Errata for OPAx344, OPAx345 Data Sheet Literature Number SBOS107 (Revision A)

The OPA344, OPA2344, OPA4344, OPA345, OPA2345, and OPA4345 devices conform functionally to the product data sheet (SBOS107A), except for the anomaly described below.

Figure 1. Corrected Typical Performance Curve

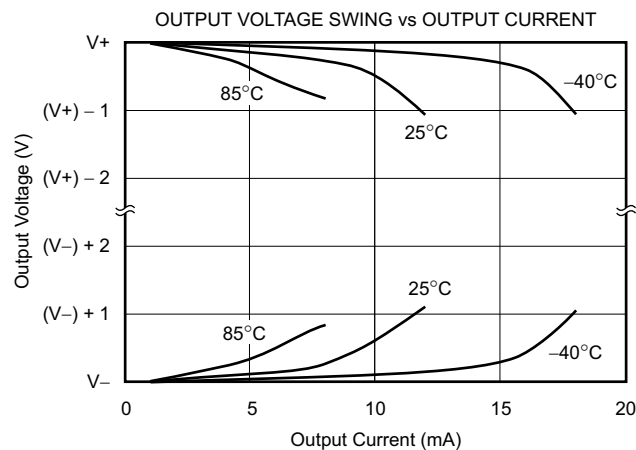
The temperature values shown in the Typical Performance Curves graph for *Output Voltage Swing vs Output Current* (Figure 14, not numbered) are incorrect.

As printed in the published product data sheet (literature number [SBOS107A](#)), the -40°C and 85°C temperature values shown in the 14th Typical Performance Curves graph (page 7) are reversed. The graph in [Figure 1](#) shows the corrected temperature values.

The -40°C and $+85^{\circ}\text{C}$ temperature labels are now correctly associated with their corresponding curve, which reflects the true output behavior of the CMOS output stage. Most customer applications employing this operational amplifier family have load currents that coincide with the typical $10\text{-k}\Omega$ load used in the Electrical Characteristics table. Currents at that level fall in the region of the graph where temperature has little influence on the output voltage versus output current performance. The correct output voltage behavior at higher load currents versus temperature can now be obtained from the graph.
